GREEN TOWSON ALLIANCE
WHITE PAPER ON SEWERS
AUGUST 31, 2017

IS RAW SEWAGE CONTAMINATING OUR NEIGHBORHOOD STREAMS?

ANALYISIS OF THE JONES FALLS SEWERSHED

JONES FALLS SEWER SYSTEM INVESTIGATION AND REPORT

MH 20755 - Map Key #13

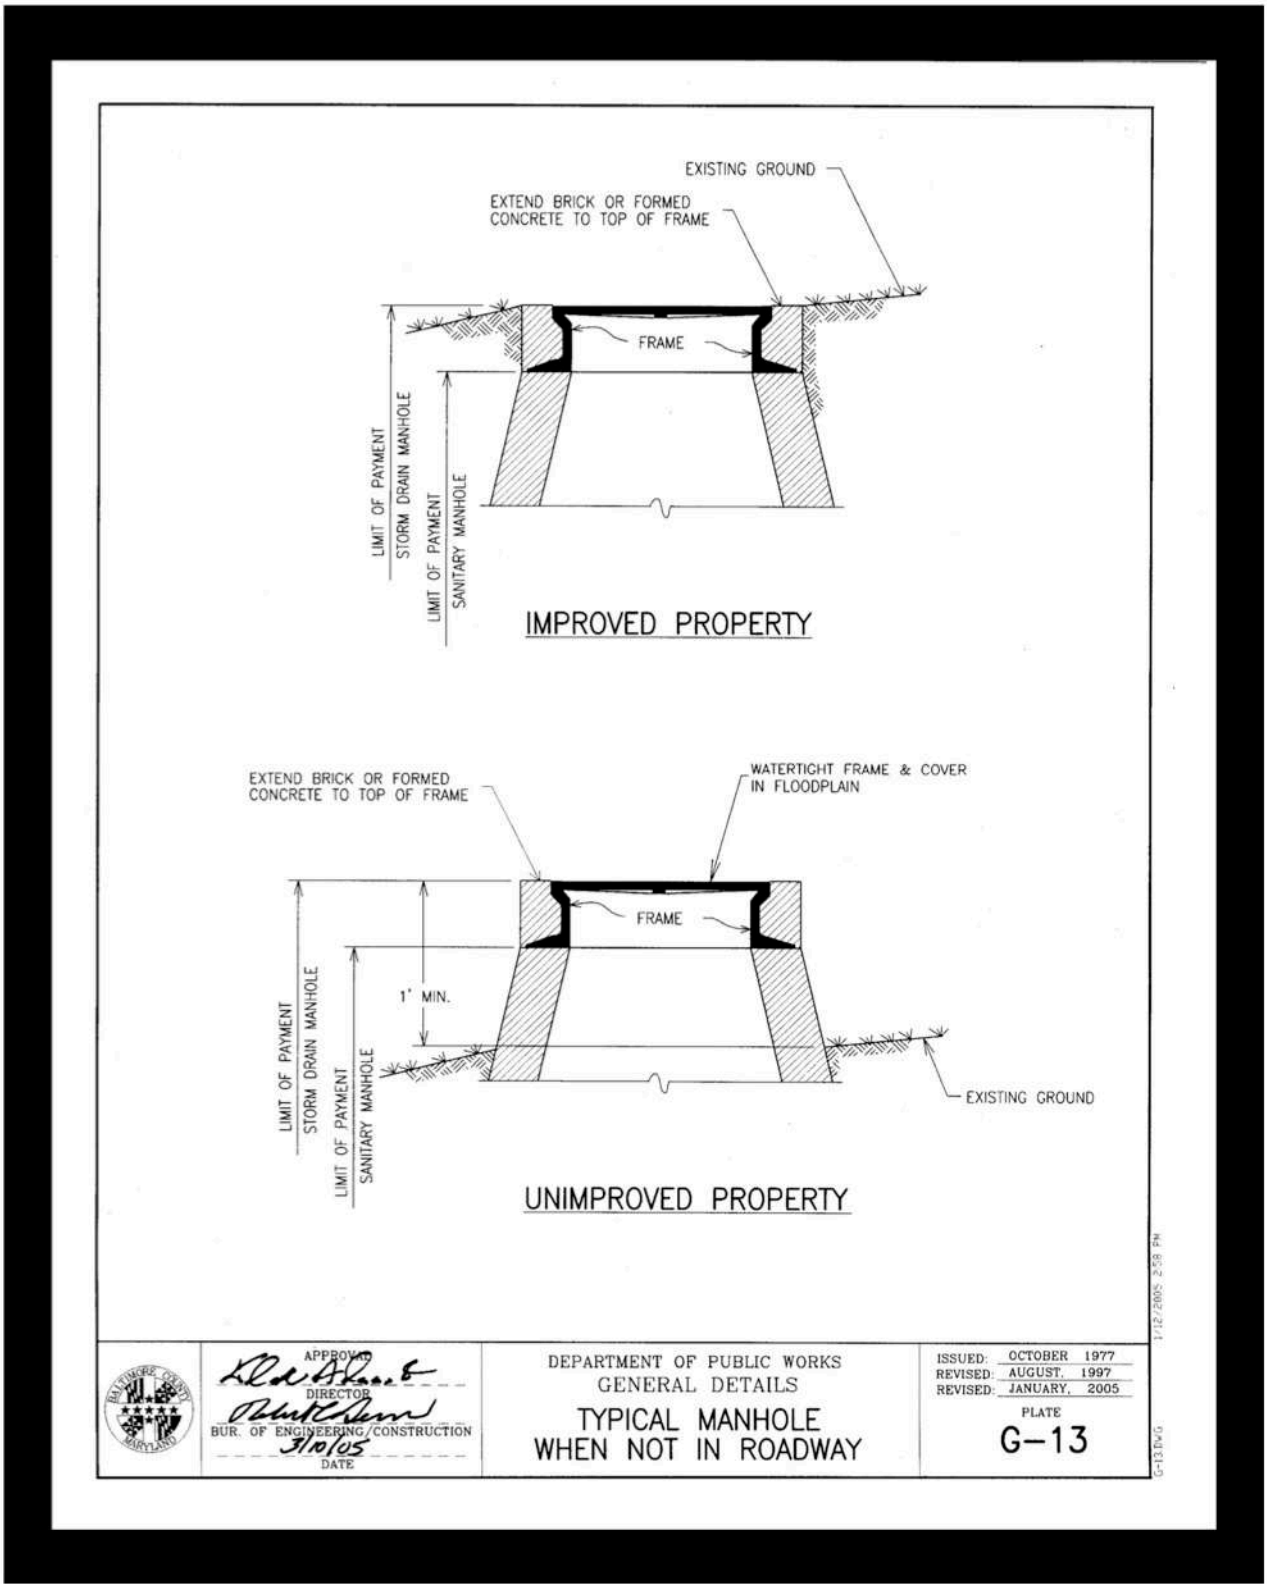
4. Some manhole stacks are not the minimum 12" above unimproved grade required by standard detail G-13:

This sewer manhole stack is flush to the ground in the Upper Jones Falls floodplain.

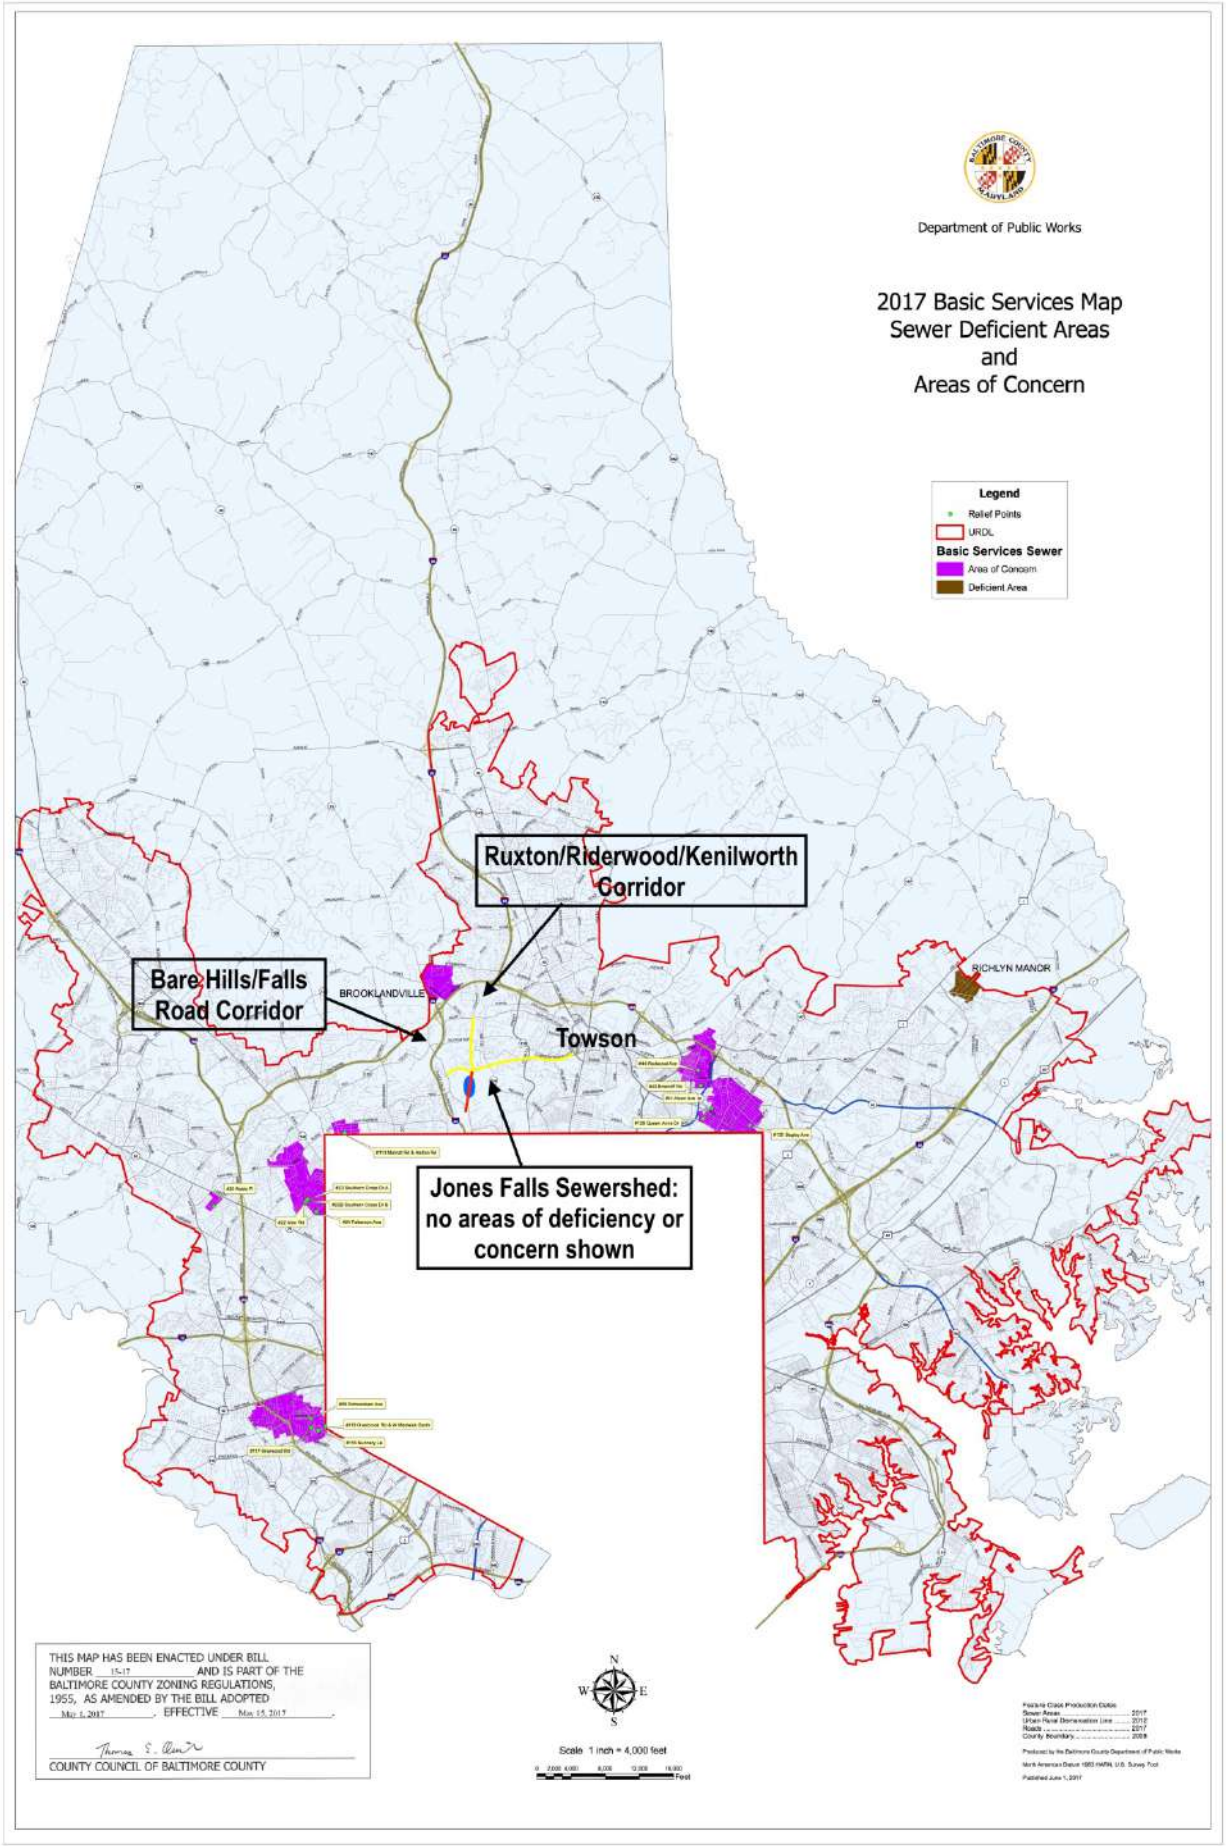
The existing sewer interceptor is seriously over capacity based on DPW data, yet did not appear as an area of deficiency on the 2016 Basic Service Map or in the 2014 Triennial Review. The Towson Run interceptor deficiencies are not on the map or in the 2014 Triennial Review either. When officials at the Baltimore County Department of Permits, Approvals and Inspections were asked why this was not on their map, the response was that the 2016 Basic Services Map does not reflect all the areas of concerns and deficiencies because if it did, there would be no development. When asked what put things on the map, the response was "actively overflowing sewers and related development restrictions." Areas that have been identified by Baltimore County to require multiple relief sewers due to capacity and other issues are not identified as either areas of concern or deficiency on the Basic Services Maps. How do the basic services maps provide development guidance, understanding of capital projects and budgets and equitable sharing of costs for infrastructure improvement needed for growth without including this information?
